# Flaws with the Alternative Evaluation of Risk Insights (AERI)

Charlyne Smith, PhD, Adam Stein, PhD, Guido Núñez-Mujica  
1/13/2023

**Abstract:** The alternative evaluation of risks insight (AERI) defined in the draft regulatory guide DG-1414 is a demonstrably conservative approach that was developed to eliminate the need to use a probabilistic risk assessment (PRA) to estimate individual event sequence frequencies. DG-1414(C)(3)(d) states “*In the absence of using a PRA to develop a realistic estimate of that annual frequency, another approach or method is needed.*” Based on LWR history, the foundation of the AERI approach approximates the sum of initiating event frequencies to one/plant-year. The ‘conditional’ risk is then defined by assuming a maximum bounding event. The AERI approach is mathematically derived based on a single bounding event, presumably through the reactor licensing period.<sup>1</sup> However, there is a disconnect in the

Figure 1. Comparison of AERI frequency assumption of reactor operational readiness following one bounding event and the historic operational readiness of reactor units following the TMI accident.

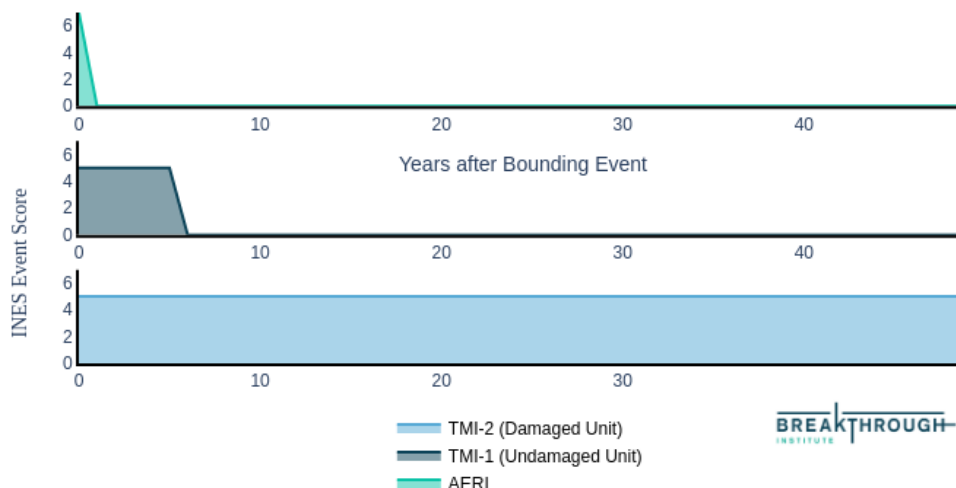
Contrary to AERI’s mathematical derivation, which takes into account a single bounding/catastrophic event, presumably per reactor licensing period, DG-1414 introduces the presumption that one bounding/catastrophic event will occur per year, per reactor licensing period. In other words, to occur on the frequency presumed in DG-1414, if a reactor experiences one bounding event within its reactor lifetime, then the process of event investigation, recovery, damage repair, and return to operation-ready status will occur within one year of the bounding event. However, this assumption is ambitious and unrealistic in reference to the historical occurrence of, and response to, reactor bounding events in the United States.

For example, the bounding event at the Three Mile Island Unit 2 (TMI-2) in 1976 was rated Level 5 on the International Nuclear Event Scale (INES) and was indefinitely shut down following the bounding event. This is contrary to the assumption stated in AERI, which implies that the reactor should be operational within one year of the bounding event. In the case of TMI-2, the investigation process alone following the bounding event spanned nine months. On the other hand, Three Mile Island Unit 1 (TMI-1), the undamaged reactor that did not experience any event, was held indefinitely non-operational following the TMI-2 bounding event. TMI-1 was non-operational for 6 years prior to the issuance of operation-ready status. Figure 1 contextualizes the assumption presented in the AERI entry condition by comparing the assumption to historical events in the US.

Figure 2. Change in population following a single bounding event over the course of the reactor licensing period and the residual dose period.

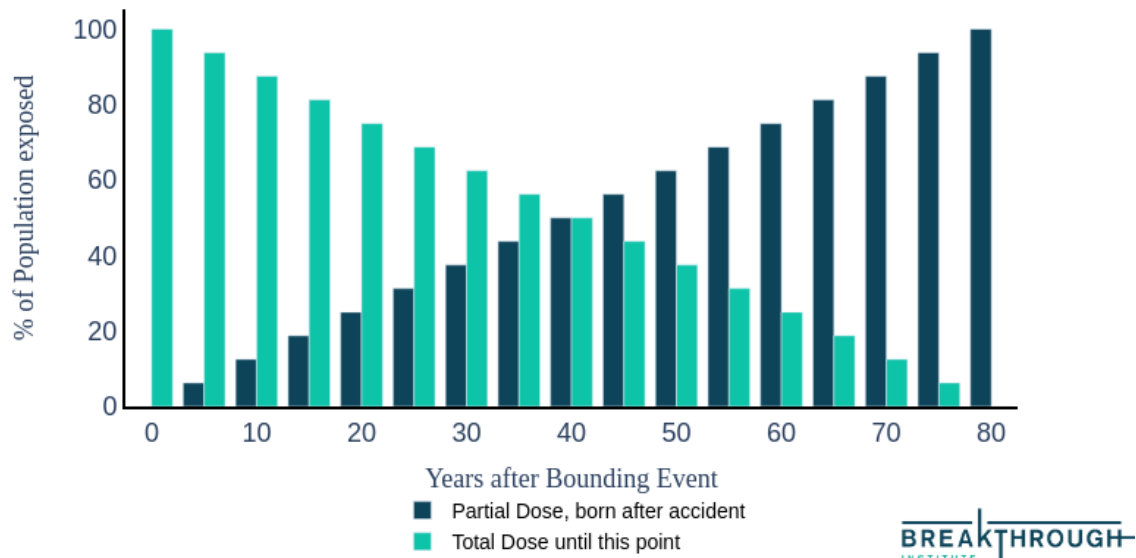
Figure 2 shows the change in population receiving partial dose versus total dose following the single bounding event. Complimentarily, Figure 3 demonstrates the cumulative offsite dose exposure to the population overtime following the single bounding event. Based on the criteria posed in the AERI derivation, if we assume that the reactor is allowed to operate following a single maximum bounding event within the first year, then by the end of the 40-year licensing period, ~50% of the population (see Figure 3) would have received a dose of 20.44 rem from the bounding event. Realistic age distribution considerations provided in subsection (c) elucidates

As per the intent of the AERI derivation, we assume a single postulated bounding event over the course of the 40-year licensing period. This single postulated bounding event will expose a population to a dose of 2.5 rem in the first year and 0.46 rem per year in the second and subsequent years. Using a population model, which assumes a birth rate of 12.5 per 1000 people<sup>12</sup>, a static population (death rate = birth rate), and a life expectancy of 80 years, we can investigate the population deceased before receiving the full dose consequence. Figure 4 shows the percentage of the population that are deceased (due to causes unrelated to plant operation) before receiving full dose from a single bounding event over the course of the licensing period and the residual dose period. The bar graph denoting the deceased population is replaced by the population born after the accident that also receives partial dose in Figure 2.

Figure 4. Deceased population that received partial dose over the course of the reactor licensing period and the residual dose period.

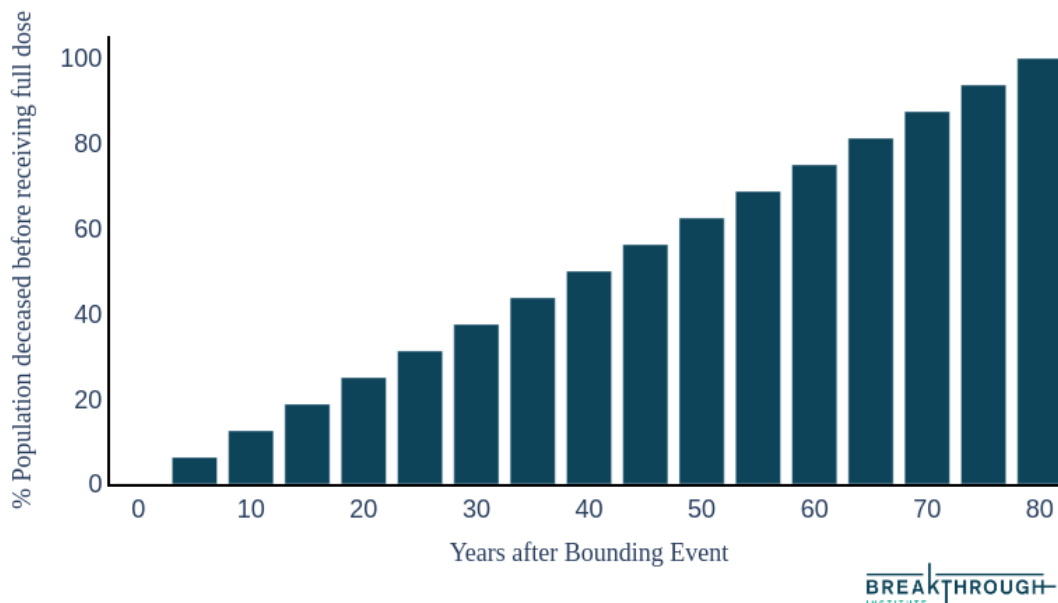
Under these assumptions that approximate actual US values, the fraction of the population that would have received the net dose during the reactor lifetime plus 50 additional years of residual dose, would be zero. If no individual, on average, experiences the entire period in this example, similarly, no one would experience the full timeline in the more complex scenario of annual events described in DG-1414. Further, no individual could receive the dose the NRC staff derived as a basis for AERI.

1414(B)<sup>15</sup>, then by the end of the 40-year reactor license period, the offsite dose to population would be 510 rem as shown in Figure 4. Furthermore, using the same model, the offsite dose limit of 25 rem would be achieved between the 6th and 7th year of consecutive bounding events.

Figure 5. Cumulative offsite dose exposure to population following annual bounding events over the course of the reactor licensing period and the residual dose period.

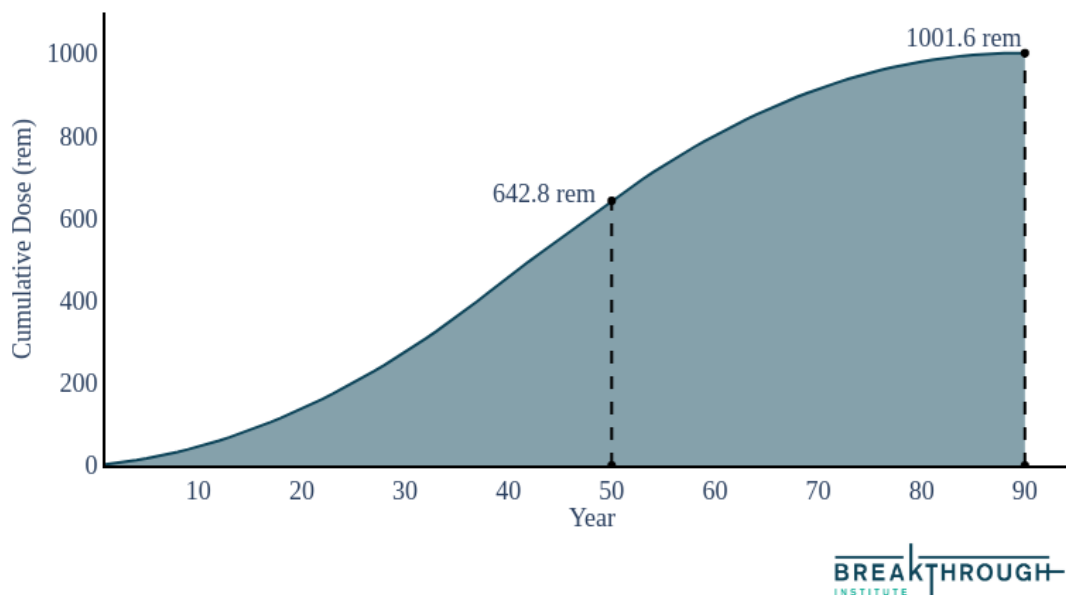
To further exacerbate the irrational basis for the AERI entry conditions, we have expanded the model to include the additional 50-year residual dose. In this regard, the total dose received by the offsite population from the 40-year reactor operation and the 50-year residual dose would be 1001.60 rem. Figure 5 shows the cumulative increase in dose exposure as a result of bounding events occurring at a frequency of 1/year. The criteria posed in AERI very easily exhibit improbable/unrealistic conservative risk estimates. A direct contradiction to the DG-1414(C)(2)(d) intent to require *“A realistic dose consequence estimate with a realistic description of the uncertainties is preferred”*.

To reconcile the discrepancies between the dose derivation and DG-1414, Section 3(d) of DG-1414 should be revised to read:

*For example, if the QHO comparison is favorable even when assuming that the postulated bounding event were to occur once ~~annually~~ **during the license of the plant**, then this is a sufficient demonstration that the QHOs are met, if supported by an explanation that the ~~once-annually~~ **frequency** assumption is clearly very conservative.*
